**SOLICITATION AMENDMENT
MODIFICATION DE L'INVITATION**

Title - Sujet Kentville Winery	
Solicitation No. - N° de l'invitation EB144-182595/A	Amendment No. - N° modif. 002
Client Reference No. - N° de référence du client EB144-18-2595	Date 2018-02-23
GETS Reference No. - N° de référence de SEAG PW-\$PWA-121-5719	
File No. - N° de dossier PWA-7-78135 (121)	CCC No./N° CCC - FMS No./N° VME
Solicitation Closes - L'invitation prend fin at - à 02:00 PM on - le 2018-03-01	Time Zone Fuseau horaire Atlantic Standard Time AST
F.O.B. - F.A.B. Plant-Usine: <input type="checkbox"/> Destination: <input checked="" type="checkbox"/> Other-Autre: <input type="checkbox"/>	
Address Enquiries to: - Adresser toutes questions à: Russell (PWA), Alex	Buyer Id - Id de l'acheteur pwa121
Telephone No. - N° de téléphone (902) 401-8180 ()	FAX No. - N° de FAX (902) 496-5016
Destination - of Goods, Services, and Construction: Destination - des biens, services et construction:

Amendment 002 is raised for the following:

Questions and Responses

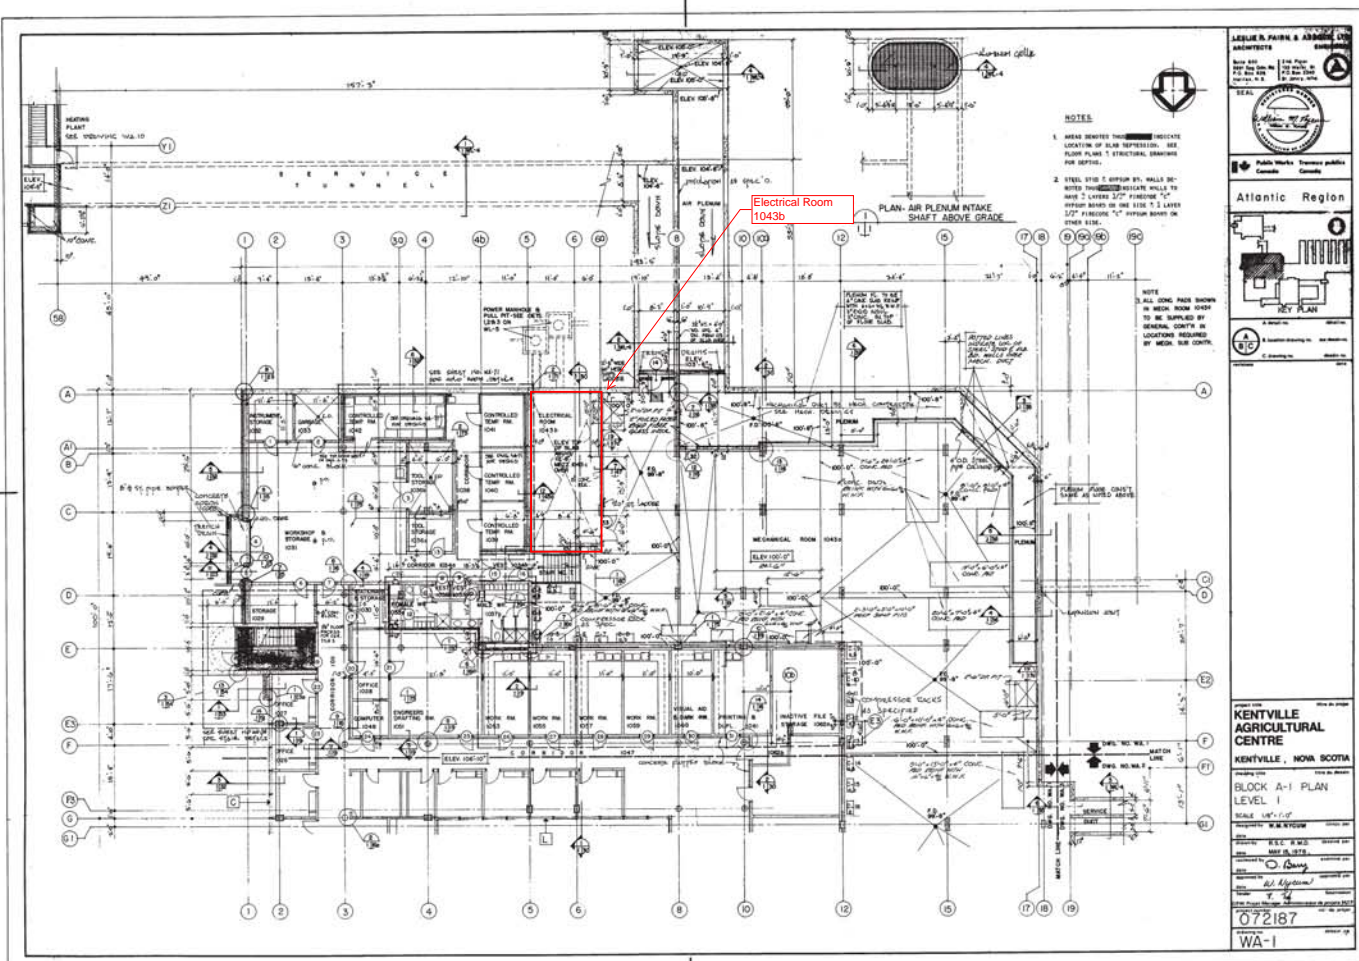
Q12 Where is the Room 1043B switchboard section 15 & 12 ? These boards are feeding Panels EM11 & 2U but are not shown on drawings?

A12 Refer to attached sketch.
